MILITARY SPECIFICATION SHEET

CAPACITORS, CHIP, MULTIPLE LAYER, FIXED, UNENCAPSULATED, CERAMIC DIELECTRIC, ESTABLISHED RELIABILITY, STYLE CDR31, METRIC

Ⓐ FIGURE 1. Style CDR31 capacitors.

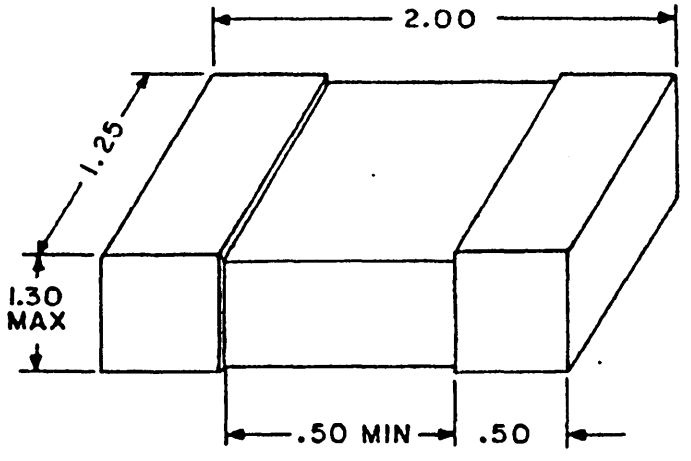
NOTES:
1. Dimensions are in millimeters.
2. Unless otherwise specified, tolerance is ±.20.
3. Dimensions and tolerances are for bare chips. For solder coated terminations add .60 to the positive length tolerance and .30 to the positive width and thickness tolerance.
4. Inch equivalents are given for general information only.

Ⓐ denotes changes
